**IEEE 1722.1**

**AVDECC Clarifications**

Marc Illouz

## 2.2 - Example of ambiguity: SAVED\_STATE flag

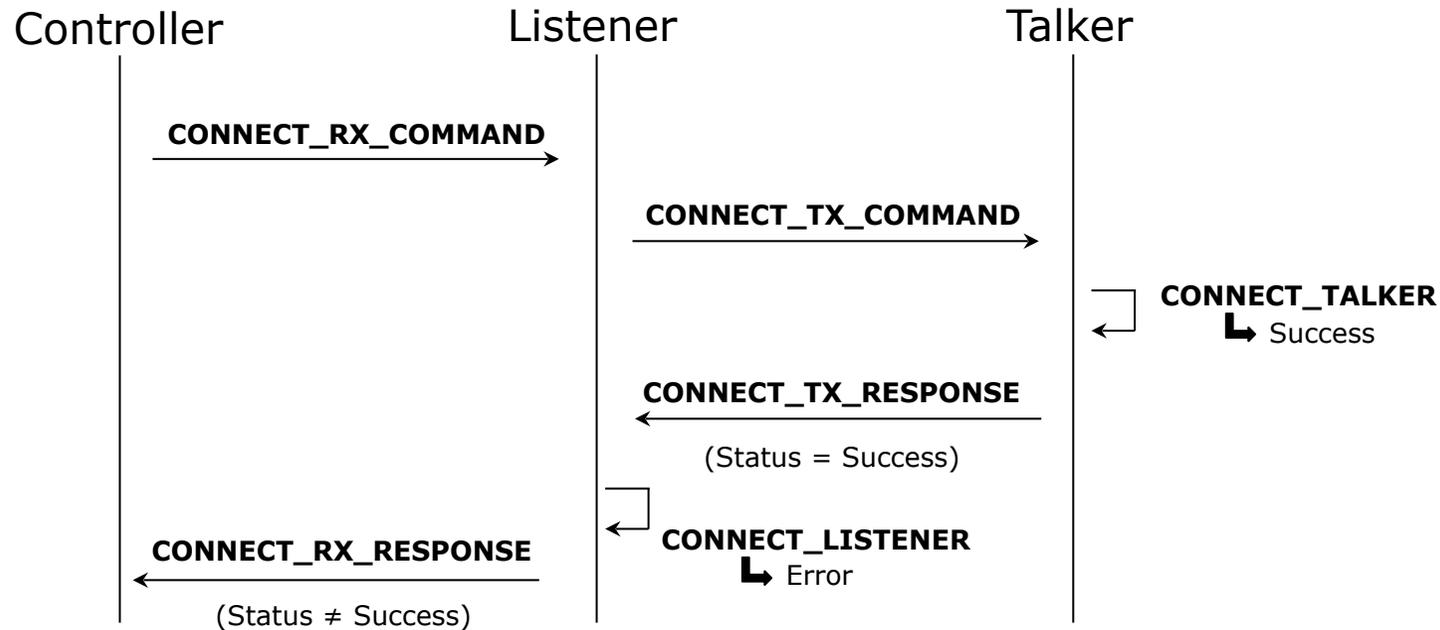
- Interpretation 1: the Listener sink is currently connected
- Interpretation 2: the Listener sink is currently connected and has saved the connection info (talker entity id, talker unique id, controller id) for use in a future Fast Connect.
- Interpretation 3: the Listener is capable of performing Fast Connect (whatever the current state of the connection)

When a sink is currently attempting “Fast Connect”: is it connected? Does it have saved state?
